MEMORANDUM

TO: District of Columbia Board of Zoning Adjustment
FROM: Jennifer Steingasser, Deputy Director Development Review & Historic Preservation
DATE: July 13, 2010
SUBJECT: BZA Case 18086 - request for special exception relief under § 223 to construct a rear deck addition to an existing single-family dwelling at 1348 Perry Place, NW (Square 2827, Lot 4)

Figure 2. Proposed Deck Plans

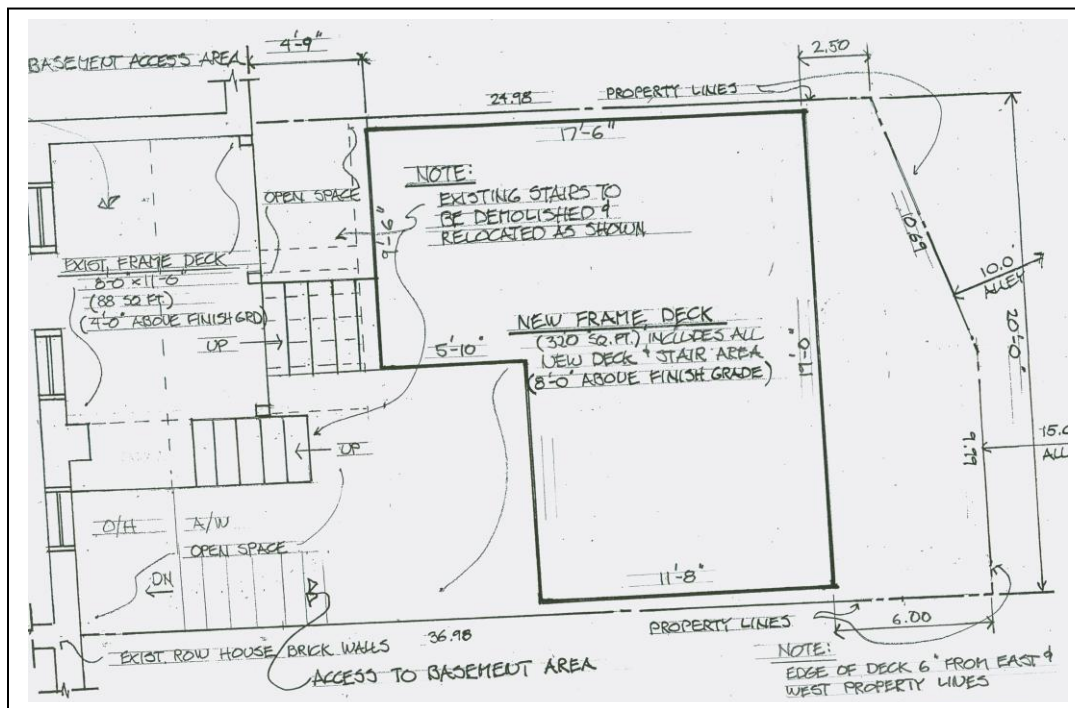
Side yard relief would be required to construct the deck shown in the plans. The proposed deck would be supported by uprights whose footings would be six inches wider than the uprights, resulting in the uprights being set back six inches from the property line. The uprights would also support seven-foot high double-faced screening fences on the east and west side of the property. The six inch gaps would constitute non-conforming side yards, which would require relief from the otherwise required 8 feet. OP would support such additional relief.

Complies: The 8-foot-above-grade elevation of the deck would cast some shadows on the rear yard of the property to the west in the morning, and to the east in the late afternoon. However, it would not unduly interfere with the light or air available to those properties.

Complies: The proposed deck's elevation could compromise the neighboring properties' privacy. However, the addition of seven-foot high double-faced fencing at the ground level may provide sufficient screening to compensate for potential intrusions on privacy. The adjacent property owners, and the owner behind and across the alley from the applicant's property, have filed letters in support expressed of the application.
